In Reply Refer To:
HSSI/B-203

Name of system:	Four Cable Transition to W-Beam Guardrail
Type of system:	High Tension Flexible to Semi Rigid Barrier Transition
Test Level:	NCHRP Report 350 TL-3
Testing conducted by:	N/A
Task Force 13 Designator:	STC02
Date of request:	October 6, 2009

GSI CABLE TO W-BEAM TRANSITION
 PATENT# 7,556,243 B2 4 CABLE SYSTEM

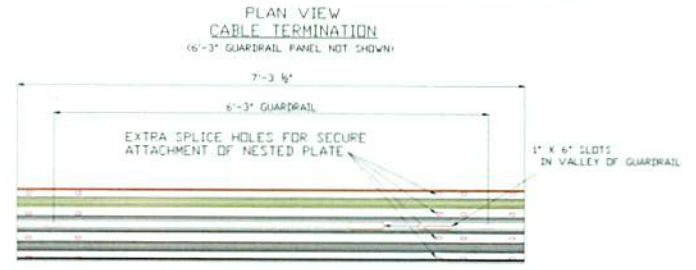
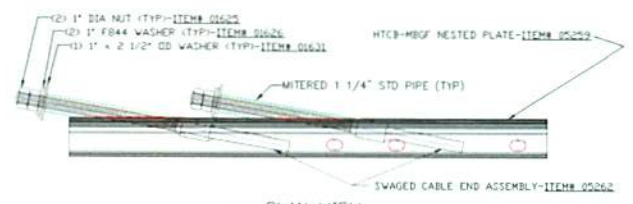
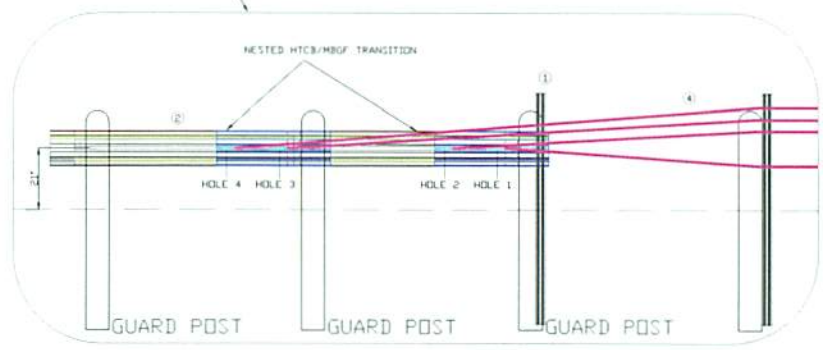
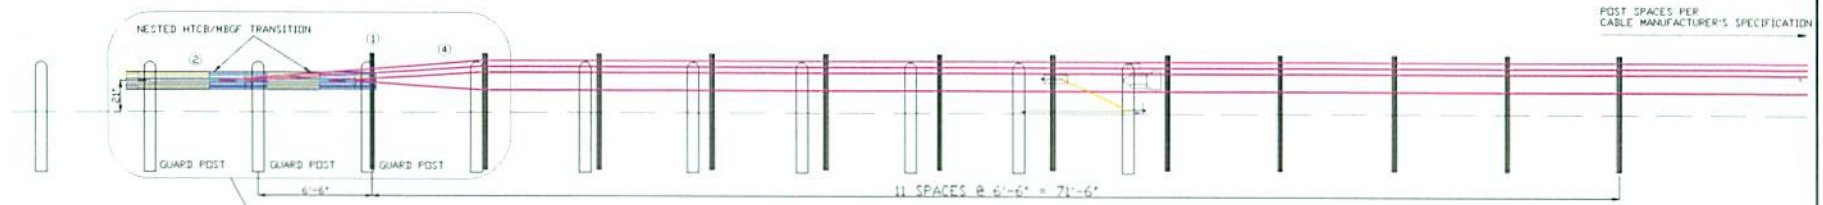
Your present request is to modify the three-cable transition to accommodate four cables. As seen in the drawing enclosed for reference, the cables attach to the w-beam rail at two separate locations. The two bottom cables attach to one panel, and the two top cables attach 6 feet, 3 inches downstream from that point. The attachments use the same mitered 1 1/4-inch standard pipes to bolt the end of the swaged cable end assemblies.

Your present request is to modify the three-cable transition to accommodate four cables. As seen in the drawing enclosed for reference, the cables attach to the w-beam rail at two separate locations. The two bottom cables attach to one panel, and the two top cables attach 6 feet, 3 inches downstream from that point. The attachments use the same mitered 1 1/4-inch standard pipes to bolt the end of the swaged cable end assemblies.

We concur that the system described above and detailed in the enclosed drawings is acceptable for use on the NHS under the range of conditions that the low-tension cable transition was tested, when such use is acceptable to a highway agency.

We concur that the system described above and detailed in the enclosed drawings is acceptable for use on the NHS under the range of conditions that the low-tension cable transition was tested, when such use is acceptable to a highway agency.
